V2500-A5/D5 SERIES PROPULSION SYSTEM NON-MODIFICATION SERVICE BULLETIN

This document transmits the Revision 2 of Non-Modification Service Bulletin V2500-ENG-72-0496.

V2500-ENG-72-0496

NON-MODIFICATION SERVICE BULLETIN – ENGINE – HP COMPRESSOR, STAGE 3 ROTOR – REPEAT INSPECTION OF CLAPPERS

Figure 1: Axial View of Clapper Showing Types of Wear

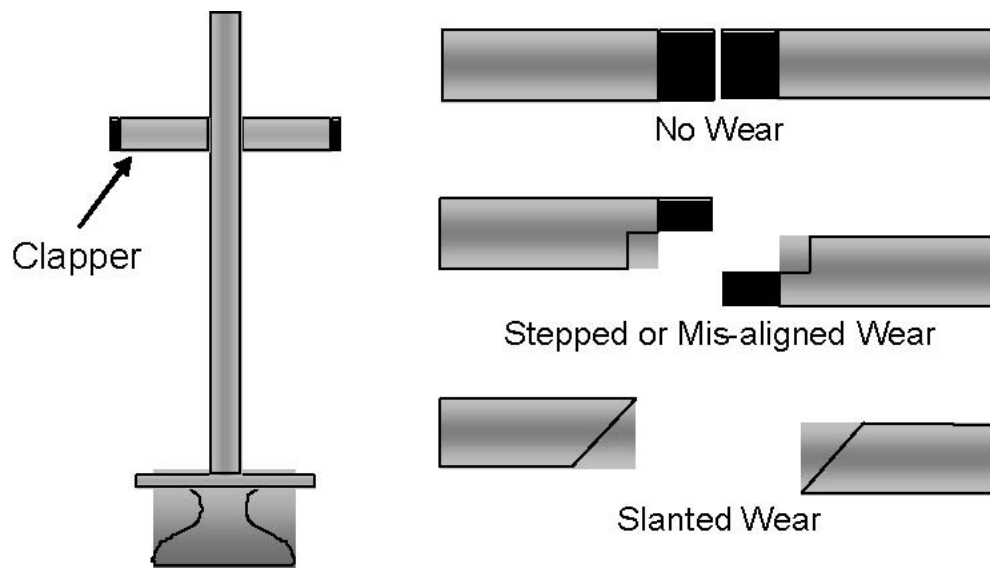
Remove	Incorporate	Reason for change
All pages of this Non-Modification Service Bulletin	Pages 1 to 23 of the Non-Modification Service Bulletin	Instruct engine removal within 500 cycles of clapper wear being classified as Amber. Definition of RED, AMBER and GREEN Inspection findings and illustration Updated

- (3) **Vertical Wear** – wear/erosion of the mating clapper faces usually due to loss of hard-face coating on one or both faces. The clapper faces are not slanted. Refer to figure 1.

- (4) **Slanted Wear** – wear between the clapper faces which is at an angle (usually 45 degrees). This type of wear shows a condition for the clappers to slide on top/under each other and become shingled. Refer to figure 1.
